PCN-20190104 TE0703-05 to TE0703-06 Hardware Revision Change

Company	Trenz Electronic GmbH
PCN Number	PCN-20190104
Title	TE0703-05 to TE0703-06 Hardware Revision Change
Subject	Trenz Electronic TE0703 Hardware Change
Issue Date	2019-04-30

This change affects all variations of TE0703 carrier of revision: TE0703-05

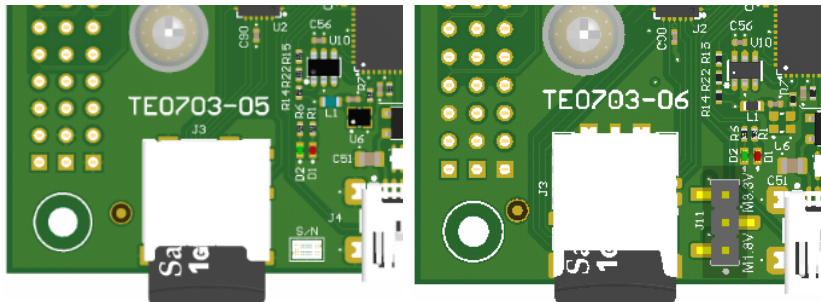
#8 Routing lenght of differential pairs B34_L17, B34_L15, B34_L21, B34_L13, B34_L10, B34_L20 changed

Type: Layout change

Reason: Other changes and limited space on PCB

Impact: Applications with exact timing requirements on these IOs have to be checked and if necessary adjusted
